Proposed Comment Resolution for the MR-O-QPSK PHY

IEEE P802.15

Title: Proposed Comment Resolution for the MR-O-QPSK PHY
Date Submitted: January 14, 2011
Source: Michael Schmidt - Atmel (email: michael.schmidt@atmel.com)
Re: Task Group 15.4g LB59 comment resolution
Abstract: Proposed comment resolution for the MR-O-QPSK PHY
Notice: This document has been prepared to assist the IEEE P802.15. It is offered as a basis for discussion and is not binding on the contributing individual(s) or organization(s). The material in this document is subject to change in form and content after further study. The contributor(s) reserve(s) the right to add, amend or withdraw material contained herein.
Release: The contributor acknowledges and accepts that this contribution becomes the property of IEEE and may be made publicly available by P802.15.

cont. CID 1185: Simulation

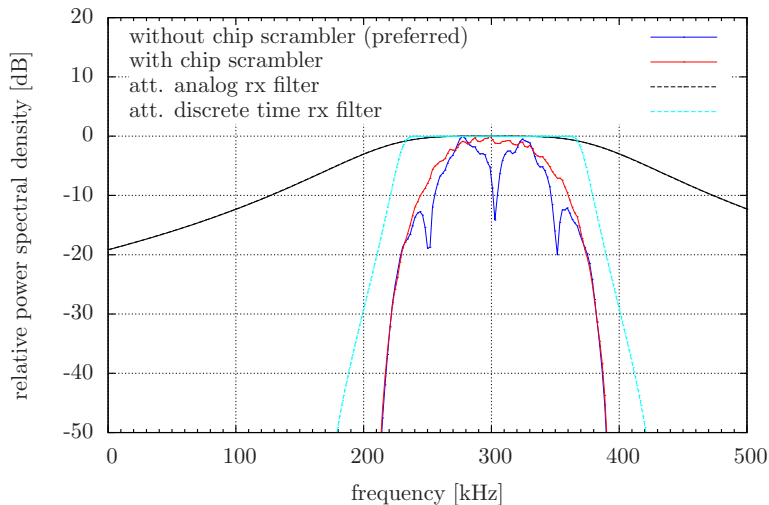
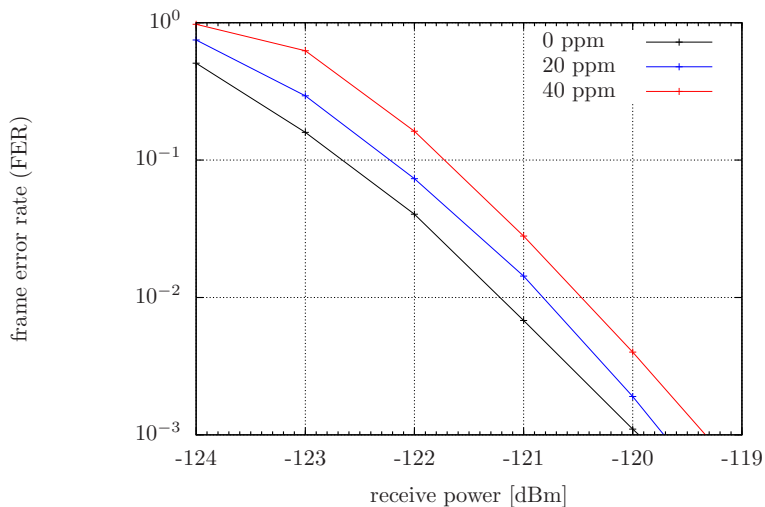
- ▶ Lower data rate should be considered in 470-510 MHz band for improved link budget.
- ▶ Add new data rate of 6.25 kbps with (8,1)-DSSS and rate 1/2 FEC.

IF:	300 kHz
analog receive filter:	2-nd order $f_{cut} = 100$ kHz
analog high pass filter:	2-nd order $f_{cut} = 50$ kHz
ADC:	6 bit at 4 MHz
discrete time receive filter:	FIR + 5-th order IIR ($f_{cut} = 62.5$ kHz)
LNA noise:	-174 dBm/Hz + 5 dB noise figure
carrier frequency:	868.3 MHz
crystal tolerance:	± 20 ppm

- ▶ true timing sync
- ▶ true frequency offset estimation

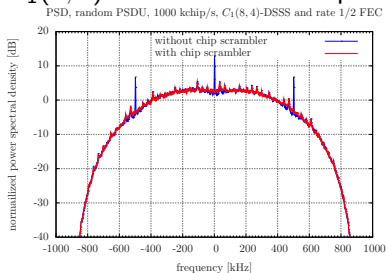
- ▶ Cross correlation of (8,4)-DSSS code is poor
- ▶ Non-coherent detection is not possible
- ▶ Consider (8,4)-DSSS code given in 15-10-0281-04-004g

- ▶ $C_0(8, 4)$ is an extended BCH code.
- ▶ The distance properties of the inner block code are less relevant (due to outer rate 1/2 FEC).
- ▶ However, the coding gain of $C_0(8, 4)$ can be exploited for a decision feedback based phase control loop³.

Spectral lines:

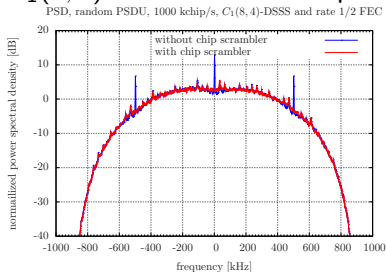
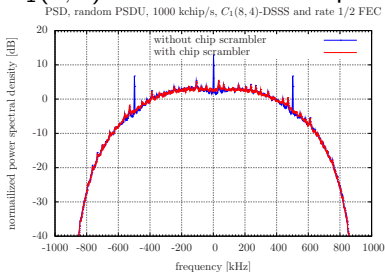
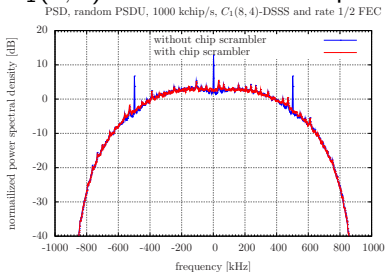
- ▶ $C_1(8, 4)$ shows noticeable spectral lines with a DC.

- ▶ relevant for operation at max. power in 902-928 MHz band (FCC §15.247: spectral density limit of 8 dBm/3 kHz).
- ▶ DC and spectral lines can be removed by chip whitening, see P802.15.4g/D2 6.12c.1.11.

- ▶ relevant for operation at max. power in 902-928 MHz band (FCC §15.247: spectral density limit of 8 dBm/3 kHz).
- ▶ DC and spectral lines can be removed by chip whitening, see P802.15.4g/D2 6.12c.1.11.
- ▶ However, any possible advantage of $C_1(8, 4)$ with regard to multipath robustness is nearly lost once chip whitening needs to be introduced anyway.
